13 April 2022 (These notes were amended 6 June 2022 to reflect changes made by the applicant subsequent to the 19 April meeting. See Notes on pages 2, 3, 9, 10, 12, 15, 17, 22, 25, 29 & 30.)

Following OGNED's meetings before the Historic Preservation Commission (HPC) on 6 & 27 April 2021, three members—Deborah Osepchuk, Lucinda Heinlein, and Jeffery Rudell—were asked by Bernie Haney, to meet and offer feedback to the development team on ways their application (the Plan) could be brought into conformity with the Architectural Design Guidelines (Guidelines). These meetings were similar to the informal weekly Tech Review meetings available to all applicants to the HPC.

Illustration B.11. — East elevation of proposed pediment-topped entry to courtyard corridor (Sheet A-5).

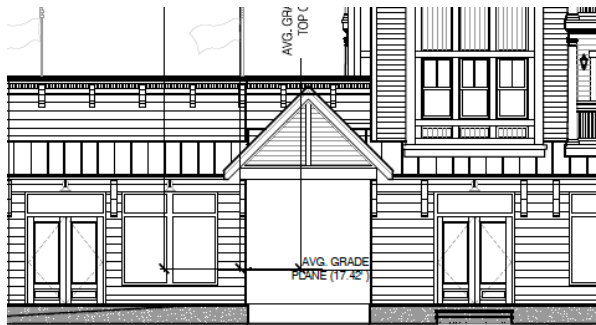
B.11. — Courtyard Corridor: At Tech’s request, OGNED agreed to reconsider the access corridor that leads from the boardwalk to the interior courtyard, to better highlight the access point and make it look more like a feature of the Retail frontage and less like an alley. At present, the pedimented entry has little relationship to the rest of the Retail area or the boardwalk itself. Tech asked OGNED to consider ways to extend that entrance forward (as a pergola or other structure extending toward the boardwalk) to better invite pedestrians into the space. The Plan presented did not activate courtyard access in any way, provided no shade, and seemed “uninviting.” No change to this area is reflected in the current Plan. **NOTE: 3 June 2022 Summary of Changes: *Windows provided in the retail spaces on both sides of the corridor passageway.***

B.12. — Courtyard Corridor: Is the entrance to the courtyard at grade (at boardwalk level) or raised to the level of the sidewalk that runs in front of the Retail? If at grade, what accommodations are made to access the courtyard entrance from the raised sidewalk? Also, will the handicap accessible ramp necessitate closing off the sidewalk with a railing where it meets the corridor entrance? (See Illustration B.11., above.)

Illustration C.8.c. — Hotel dormers, north elevation, showing two sets of double windows beneath a shed roof (Sheet A-12).

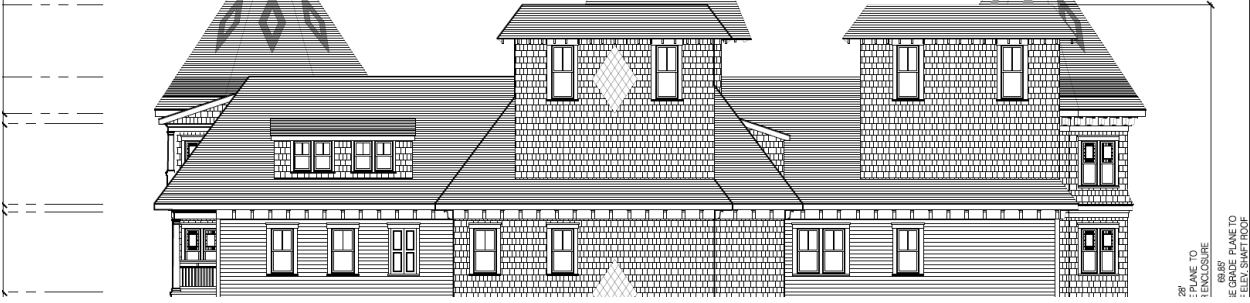
C.8. — **Hotel: Dormers.** OGNED presented designs with individual dormers, double (or paired) dormers, gabled dormers, shed dormers, and combinations of all four. Tech questioned whether mixing of dormer styles—shed and gable—magnified the weakness of secondary elements such as the proposed horizontal roofs on the elevator shaft and stairway towers. Tech suggested gable dormers would better re-enforce the verticality of primary elements such as the corner tower roofs, and be more in keeping with the Queen Anne style. **NOTE: 3 June 2022 Summary of Changes: Revised detailing at roof-top dormers. Half-size columns removed and replaced with large brackets. Dormer roof changed from shed to gable to accommodate the revised detailing. Dormer width enlarged to accommodate (1) wall lantern on each side of the doors.**

Illustration C.9. — Hotel dormers, south elevation, showing proposed paneled gable ornamentation (Sheet A-11).

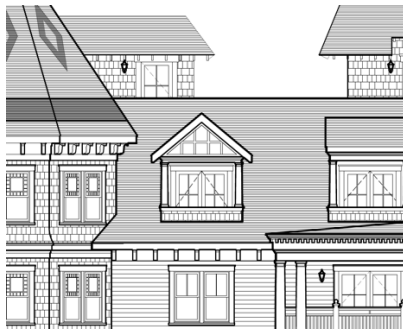
C.9. — **Hotel: Dormers.** The inclusion of paneling in the dormer gables at the south and east is historically inappropriate. Examples exist of doweled screens and orthogonal lattice in gables, but paneling of this sort is not appropriate.

Illustration C.10.a. — South elevation of Hotel dormers showing proposed mini-Tuscan columns (Sheet A-11).

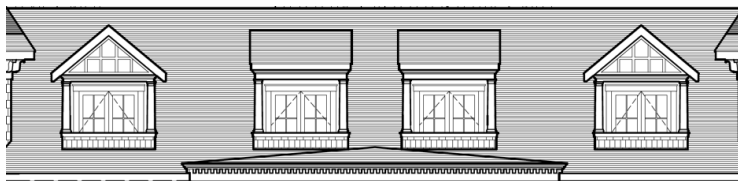
C.10. — **Hotel: Dormers.** Use of Tuscan columns on roof dormers on the south and east elevations are inappropriate. Properly scaled corbels, similar to those used at the tower balconies below the pent, are more appropriate and would help unify the design through repetition. **NOTE: 3 June 2022 Summary of Changes: Revised detailing at roof-top dormers. Half-size columns removed and replaced with large brackets. Dormer roof changed from shed to gable to accommodate the revised detailing. Dormer width enlarged to accommodate (1) wall lantern on each side of the doors.**

Illustrations C.14.a., C.14.b., C.14.c., and C.14.d. — The north, south, east, and west elevations of Condominium Building One showing non-conforming faux-gables, balusters and rails, cupola, and stair towers (Sheets

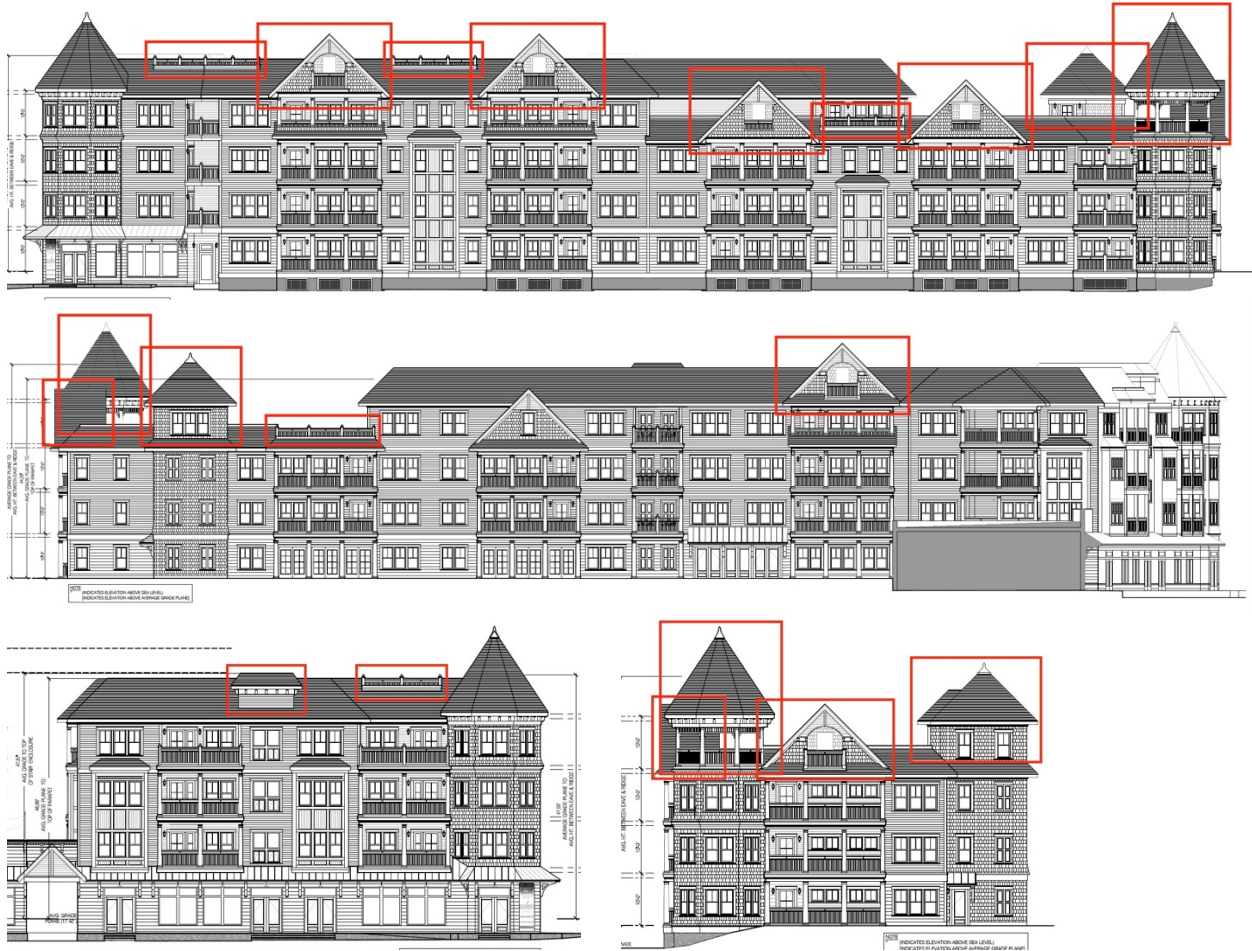
C.14. — **Condominiums:** Rather than strong, historically appropriate, roof forms, the Condominium buildings display disparate architectural elements that fail to unify or strengthen the design. These include a parapet roof meant to suggest a faux-Mansard roof, railing breaks in the parapet with short runs of newel posts and balusters, (that work against the faux-Mansard illusion), stair towers at the east and west elevations that penetrate the parapet, and unusual, non-historic faux-gables with cut-out openings, that further emphasize the non-historic roof treatment. **NOTE: 3 June 2022 Summary of Changes: Sidelights removed on porches/balconies. Removed all visible roof railings on North and East Elevations. Removed visible roof railings on Building Two. Finials added to the towers. Roof top dormers (on 3-story portion of the building) increased in depth. Roof top dormers on Building Two increased in depth.**

Illustration D.2. — The south elevation (Sheet A-11) showing proposed double set of double ½ doors, with non-conforming single side-light windows to the left and right.

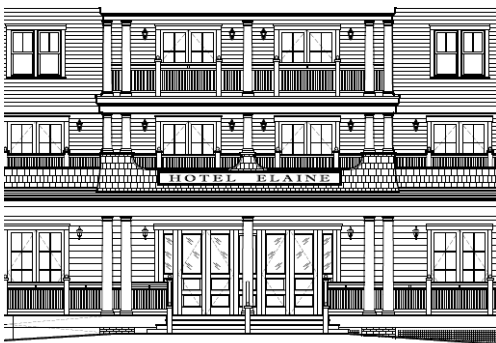
D.2. — **Hotel:** In elevation, the Hotel’s main entrance doors are flanked by single sidelight windows on the far left and far right of the two sets of doors (with possibly a third window occupying the area between sets of doors). However, the plan view shows only doors, and no sidelight windows. Sidelight windows should flank each set of double doors or be eliminated completely. Please clarify.

Illustration D.3.a. — South elevation of Hotel dormers showing proposed double doors (Sheet A-11).

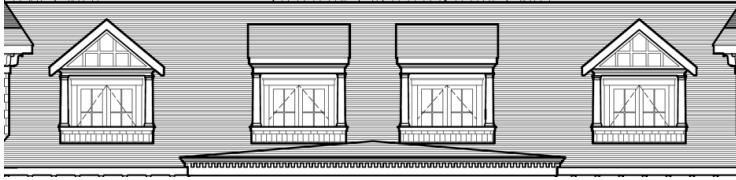
D.3. — **Hotel:** Double doors proposed for dormers are over-scaled and leave no room for lighting fixtures (which are not shown). Single doors would be more proportional in dormers of this size.

Illustration G.4.a. — Second floor plan of Condominium Building One showing hybrid inset balconies at all four elevations (Sheet A-2).

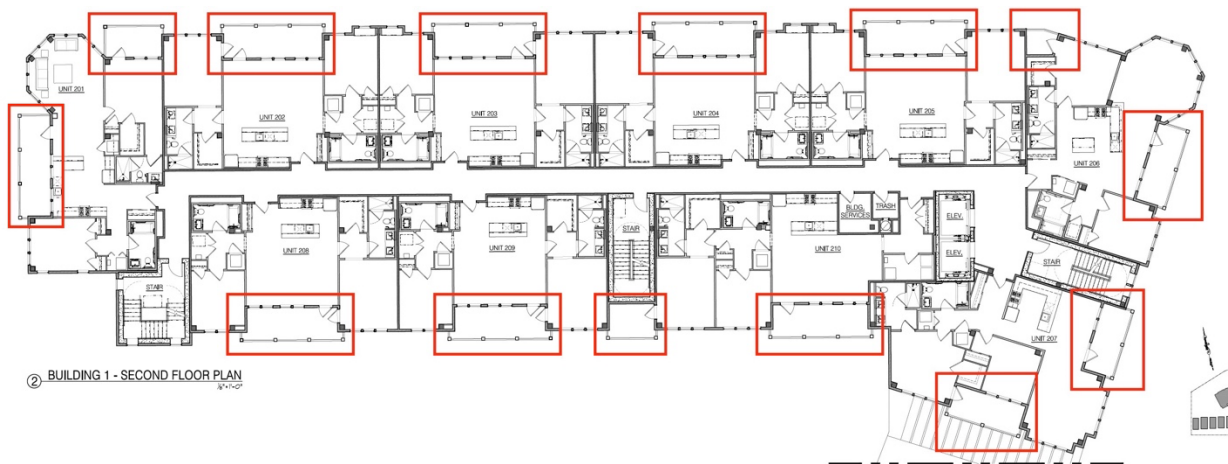
G.2. — **Condominiums:** Inset balconies are counter-historical, especially when used in place of porches. Porches usually project from a building face, provide a human scale to buildings by visually stepping down in size from the body of a building, and add visual interest to buildings by relieving visual mass. Porches enhance a sense of community and promote interaction between a building and its surrounding streetscape. Inset balconies are carved into buildings, are often cut off from the surrounding streetscape, and do not promote interaction. OGNED offers neither strict porches nor strict inset balconies, but rather hybrids where the majority of the open-

air spaces are inset into the body of the buildings with minimal extensions. These limit the change in plane of the buildings, contribute to the visual mass of each structure, and inhibit the sense of community that is vital to Ocean Grove. Tech considers these hybrid balconies non-historic and non-conforming.

Illustrations G.5.a. and G.5.b. — Detail of northeast corner of Condominium Building One showing windowless mini-balconies above the north building access door (Sheet A-6). These balconies are circle in the second-floor plan, at right (Sheet A-2).

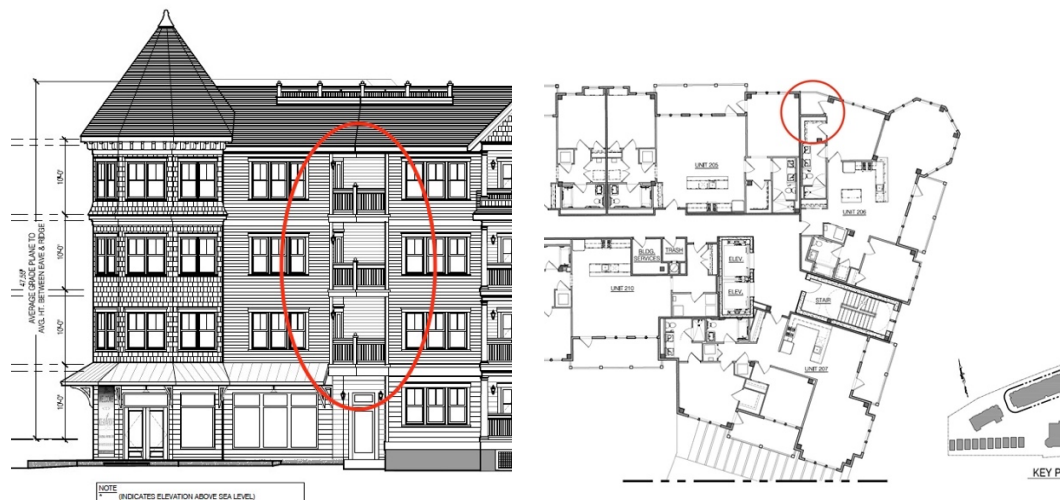
G.5. — Condominiums: At the north elevation, just west of the Building One tower, above the north access door, are a row of inset-balconies. These balconies occur at the point where the building jogs southwest along Wesley Lake. These balconies are five-sided, due to a bend in their railings, have no windows, single doors, and no lighting. They are non-historic in character, awkward in size and placement, and differ in every way from any other balcony in the project. Tech recommends they be reconsidered or eliminated. **NOTE: 3 June 2022 Summary of Changes: Shutters added at inset balcony on the North East corner.**

Illustration H.6. — Plan showing proposed Condominium Building One roof path and roof deck (Sheet A-4).

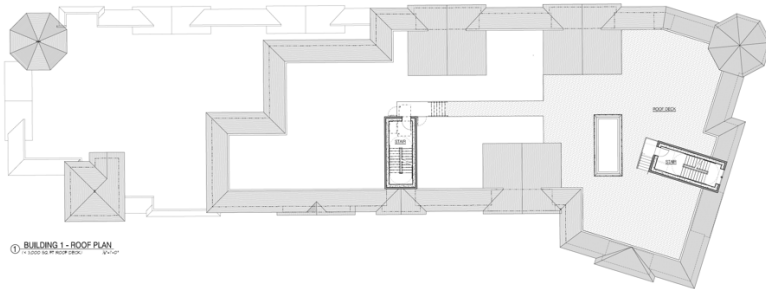
H.8. — **Condominiums:** Are railings proposed for the rooftop pathway and roof deck of Condominium Building One? Please provide cat/cut for review.

Illustration N.1.a. — Proposed coverage of Hotel Roof deck (emphasis added) (Sheet A-10).

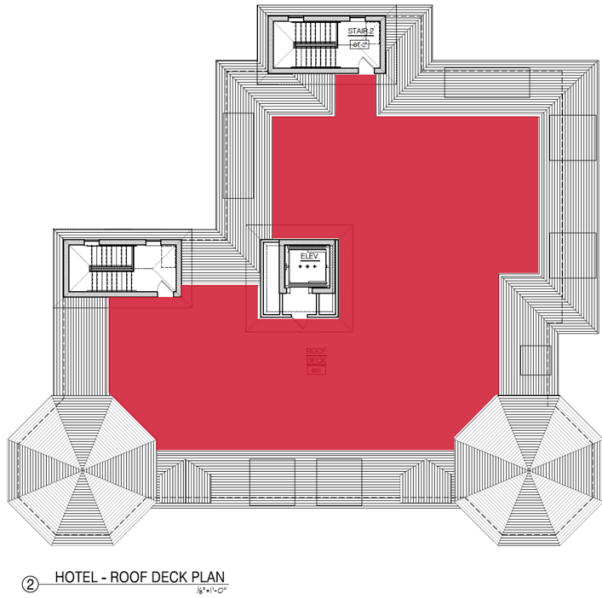
N.1. — **Roof Decks.** The Hotel & Condominium Building One each have large-scale, public roof decks. Condominium Building Two has three private roof decks. Roof decks are non-conforming with the Guidelines. The roof decks proposed are visible in so far as railings and balusters along the parapet provide “viewing platforms” (some beneath the proposed faux-gables). These breaks in the parapet reveal the presence of the roof decks. There is a reasonable expectation that appurtenances related to roof decks (umbrellas, tents, pergolas, rooftop plantings, lighting, etc.) will further reveal the presence of these roof decks atop these buildings. (See, Guidelines, page 27, Section N, “Roof top construction featuring sun decks, swimming pools, and hot tubs are not in keeping with the designs of the Victorian Era nor other historic styles of architecture within the Ocean Grove Historic District. Therefore, such features will be viewed contrary to the “Spirit” of the architectural setting. Introduction of any such feature must fully demonstrate that such a feature would be designed so as not to be visible to public view...”)
